**AGENDA
PLANNING & ZONING COMMISSION
THURSDAY, November 14, 2019
7:00 P.M. TOWN HALL**

TITLE: Continued Public Hearing - Sopris Lofts – 1201 Colorado Avenue
Major Site Plan Review, Conditional Use Permit, Alternative Compliance
and an Amendment to Ordinance No. 18, Series of 2016

LU19-20-20 Stein 133 and Main - Major Site Plan Review - RESPONSE

TITLE: Sopris Lofts – 1201 Colorado Avenue
Major Site Plan Review and Conditional Use Permit

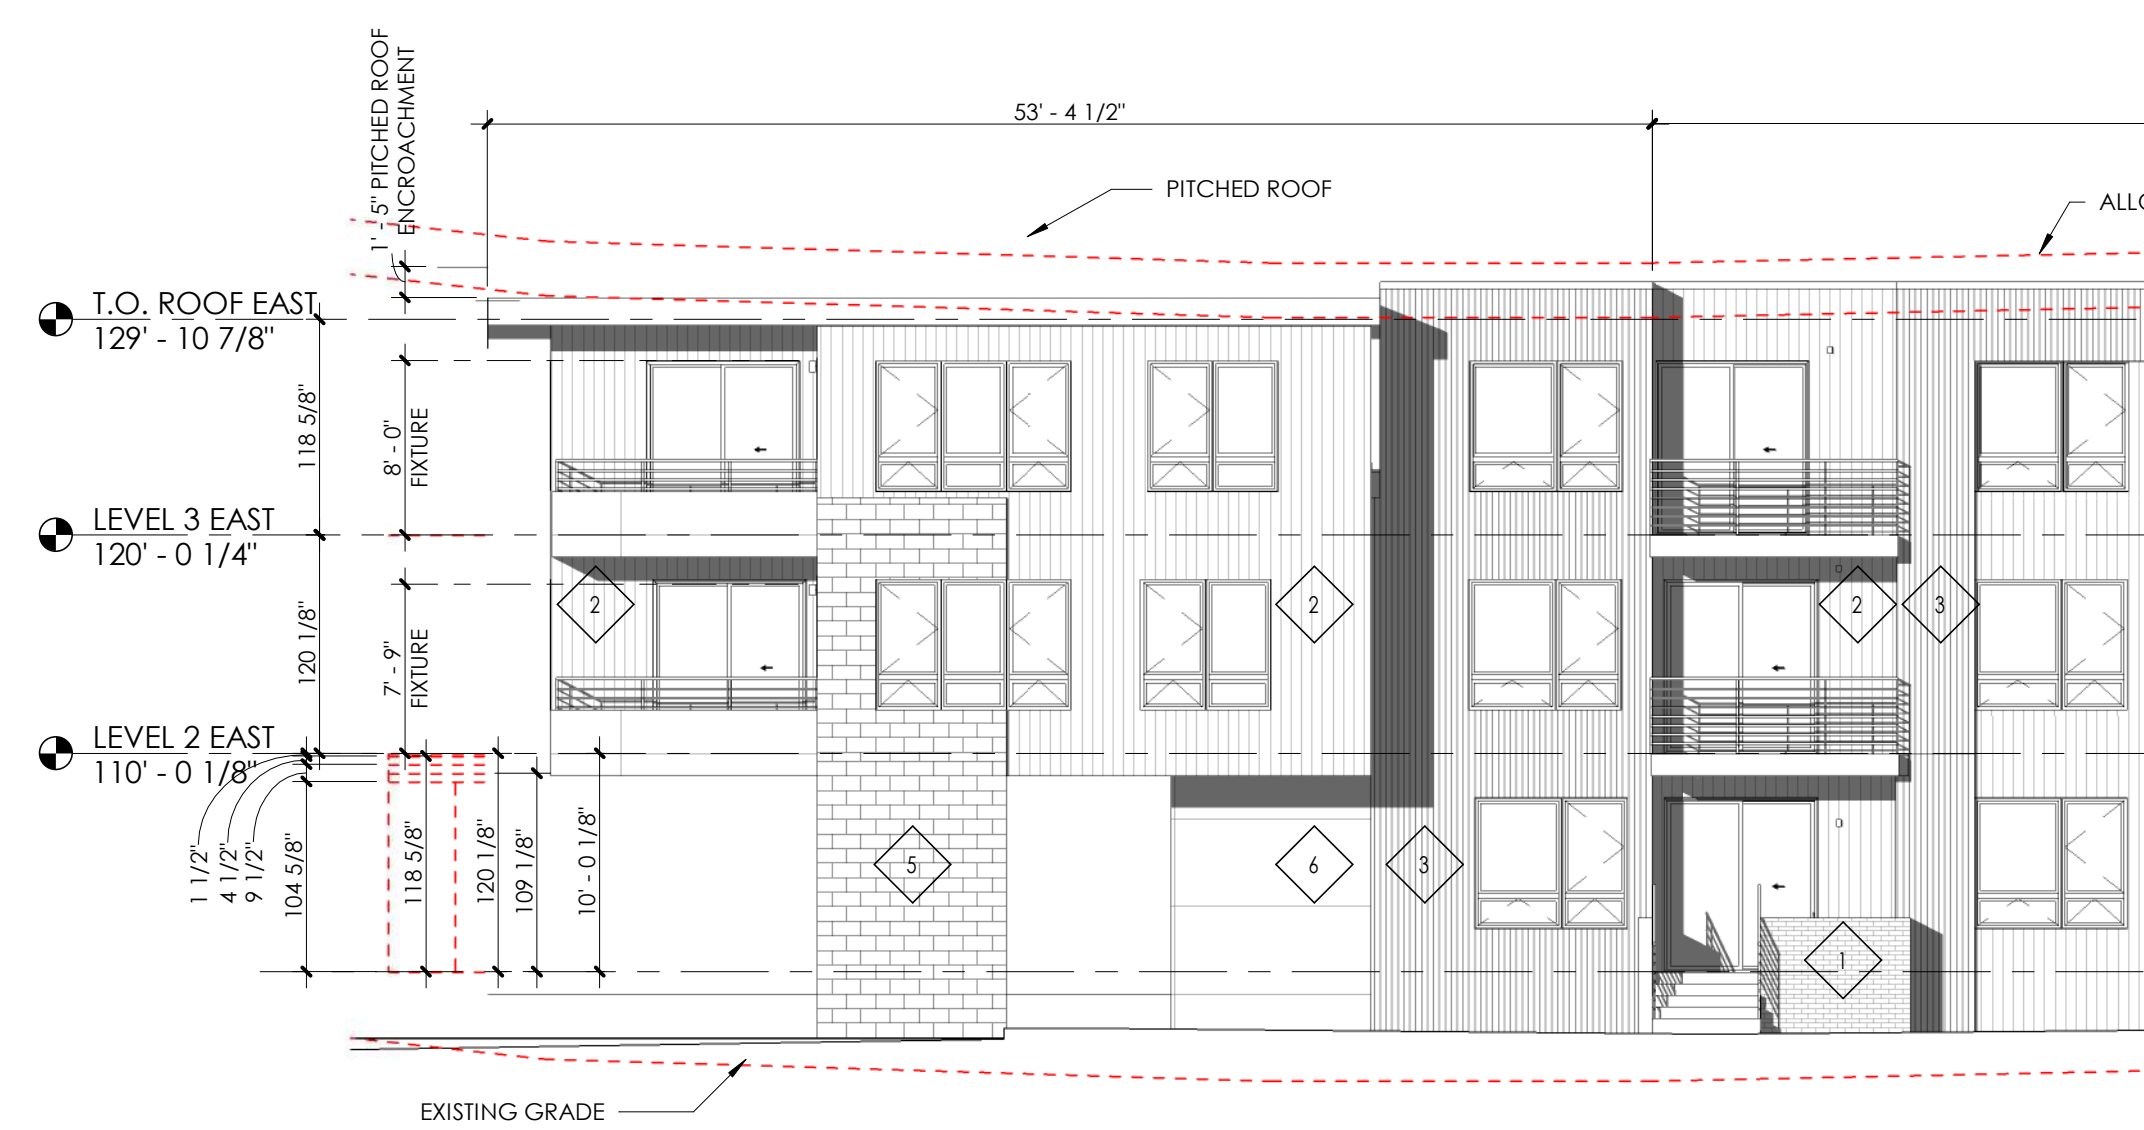
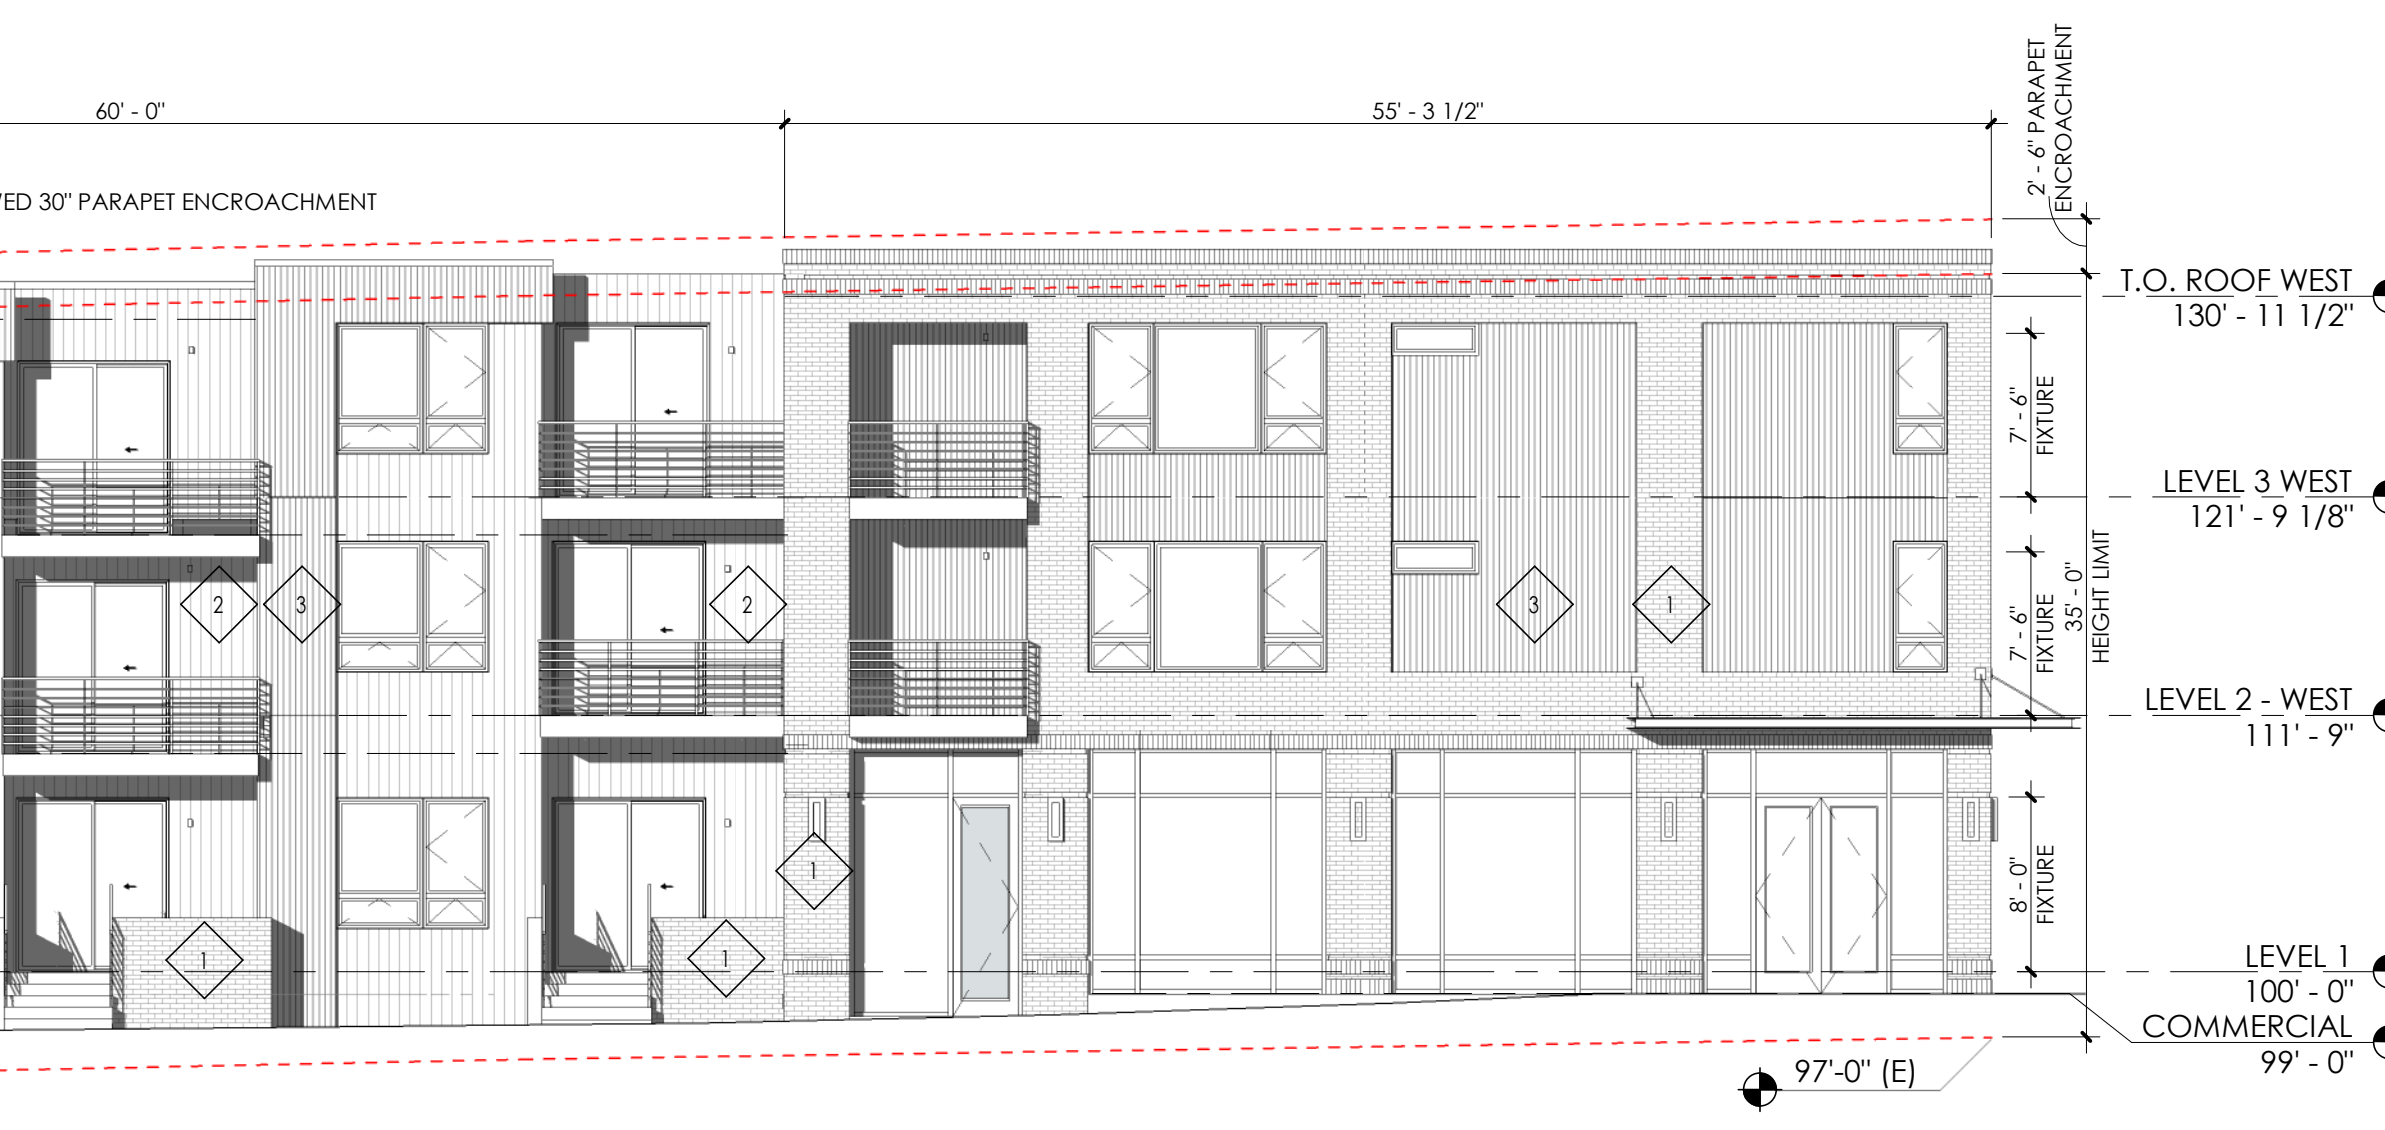
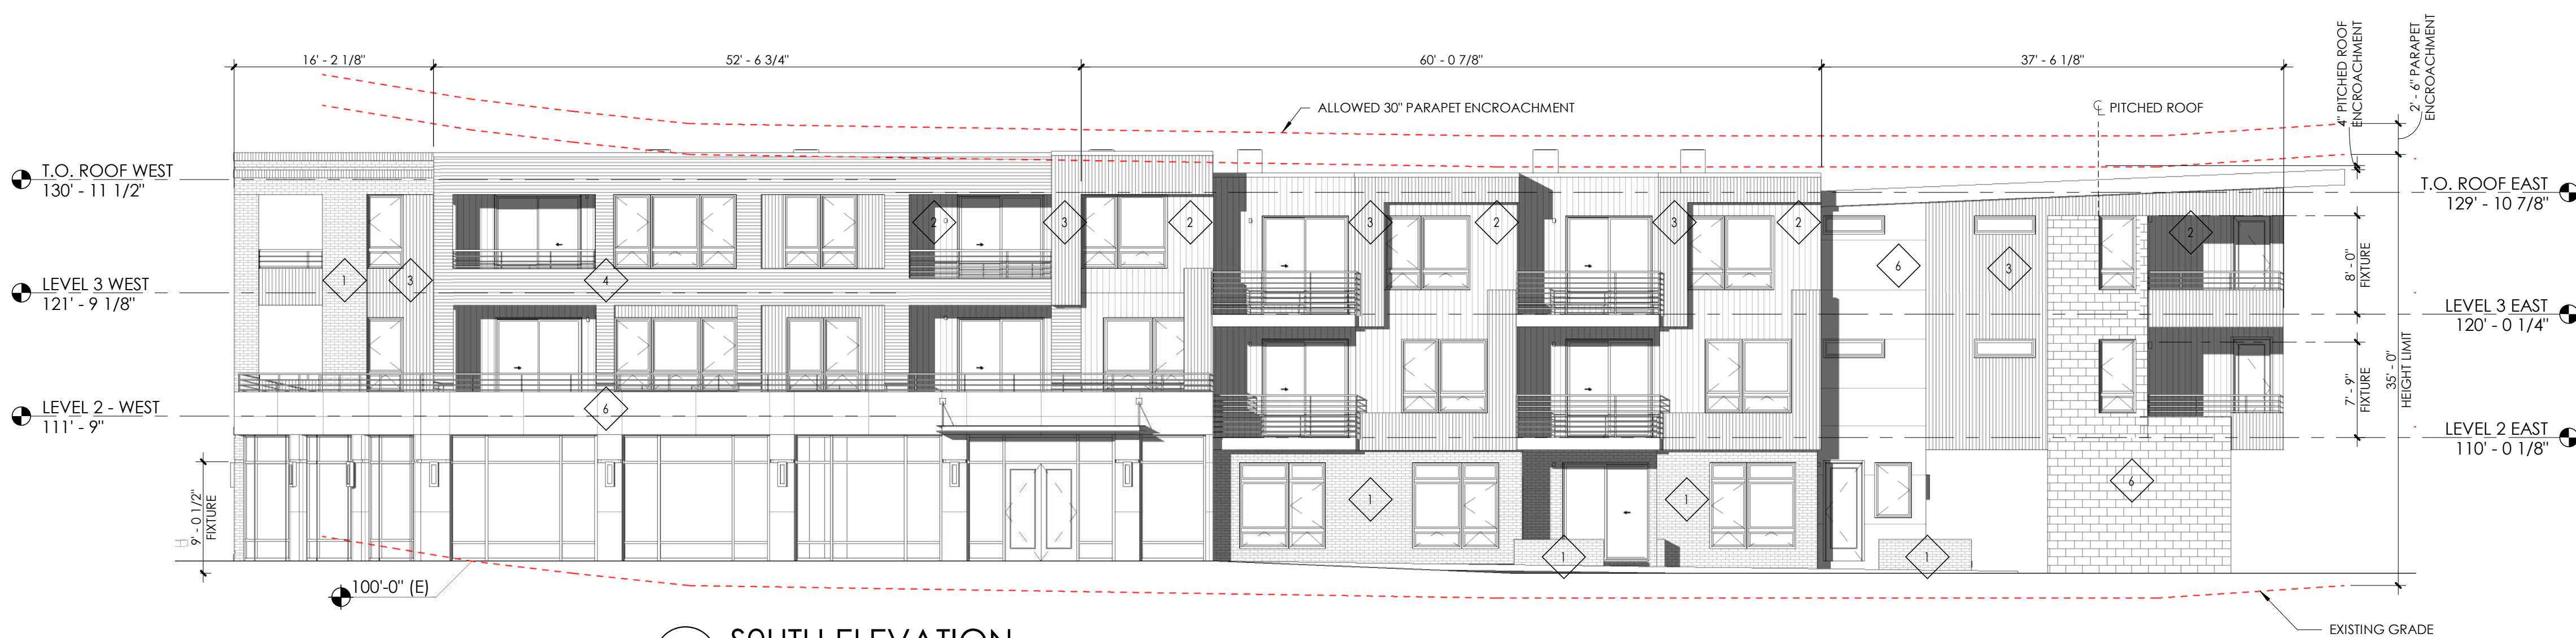
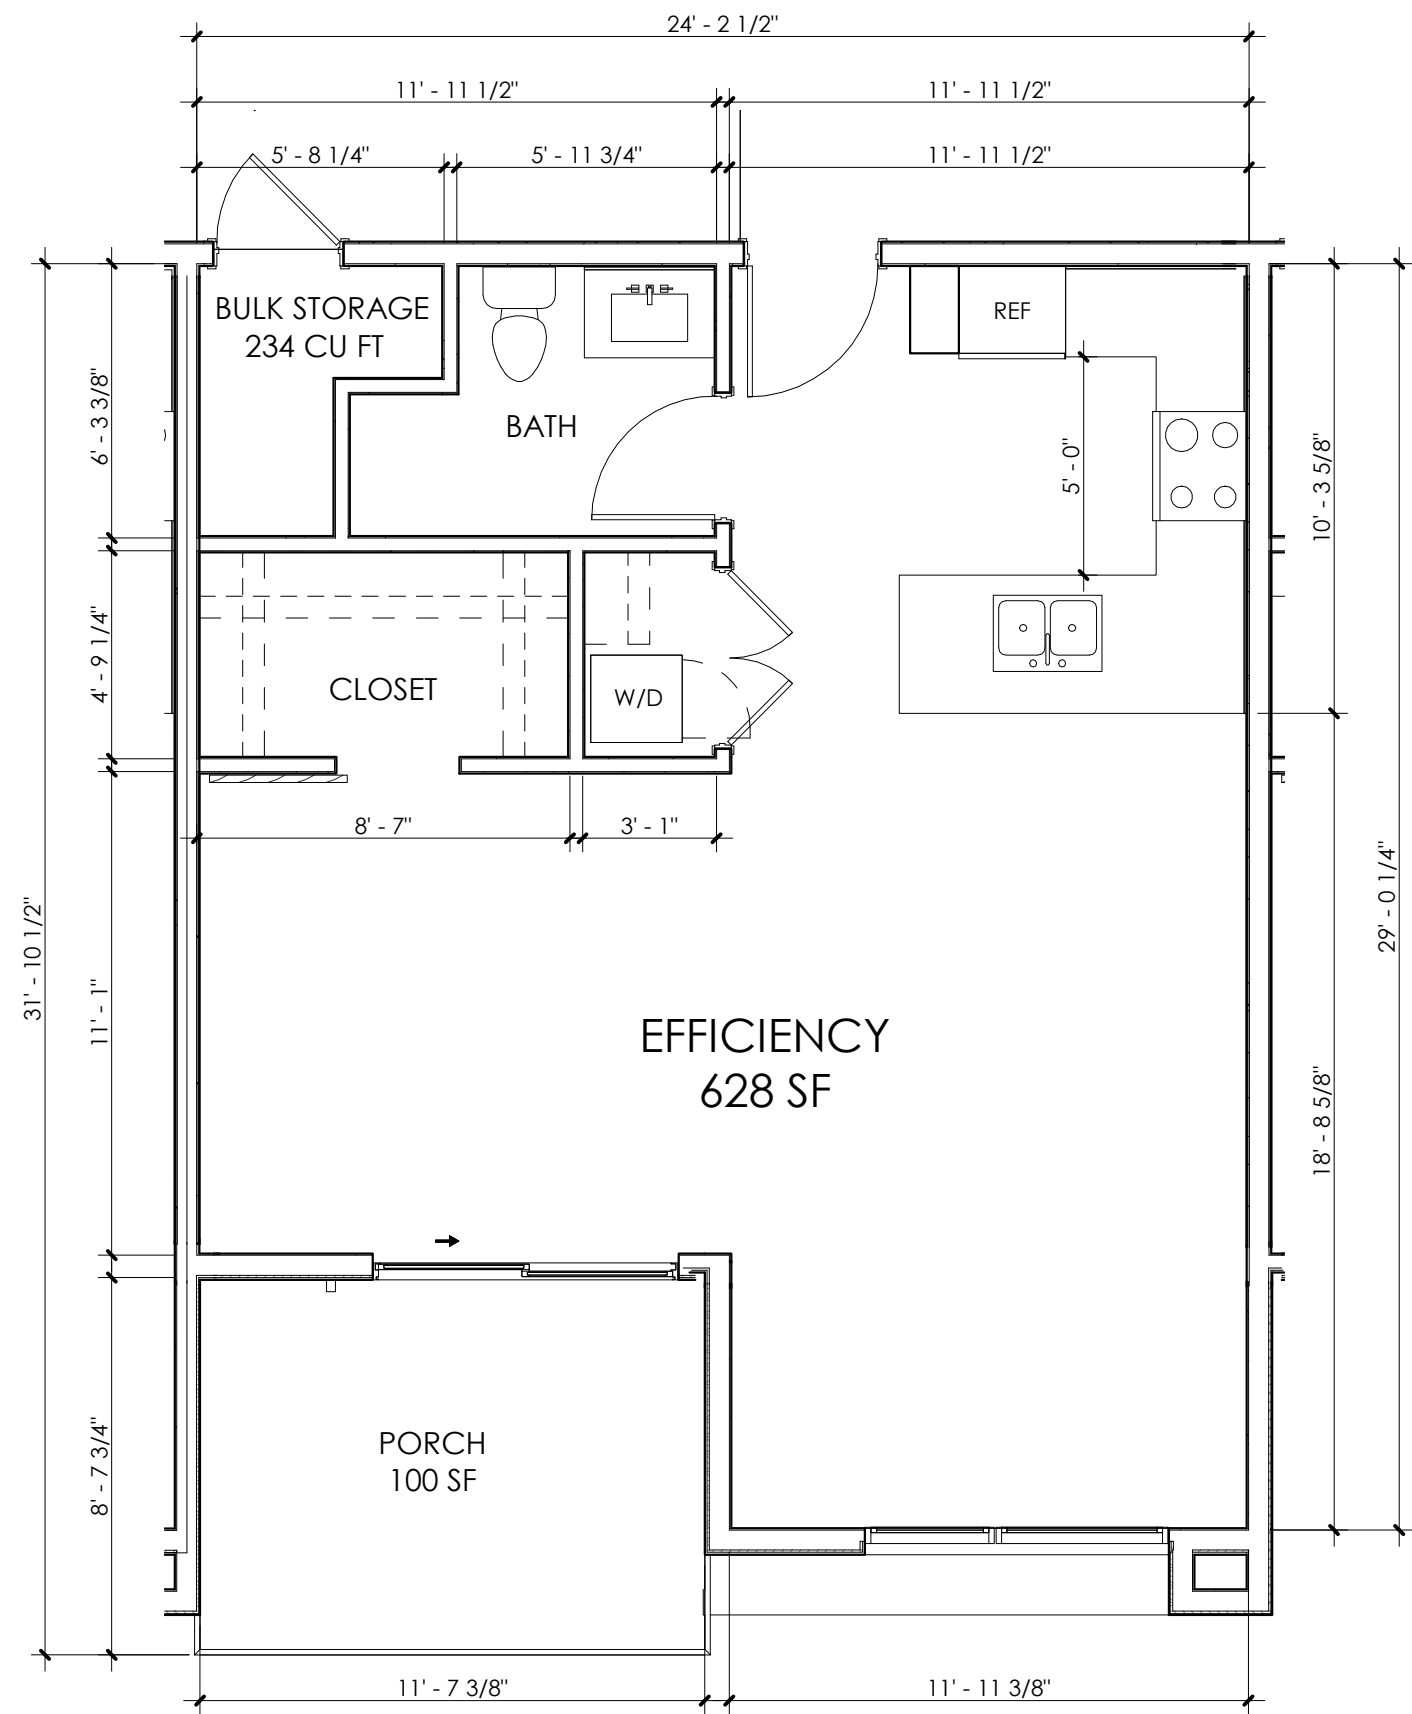
There are a number of code sections related to building design which Staff has listed below which need additional attention. Staff does not feel that the commercial portion of the building along Highway 133 and Main Street is in compliance with these sections. There are also some questions about the building overall as it relates to horizontal articulation and the roofline. Many of these code sections are duplicative because of the various design standards which apply to mixed-use buildings.

We have produced additional renderings at ground level that demonstrate how the roof forms change along the façade. Please refer to elevations on A4.01 for the linear measurement, height differences, and orientation of the roof forms. Please refer to Exhibit 6 for updated renderings showing changes in the roof forms.

Building elements have changes in wall planes of greater than 12" to help modulate the building. Please refer to the plans and elevations for linear dimensions of building elements.

Please refer to building plans for changes in wall planes and elevations for compliance with horizontal articulation. Masonry is used at the base to 'ground' the building and helps to break the mass down to a scale that relates to the human body. Refer to renderings (Exhibit 6) for further illustration.
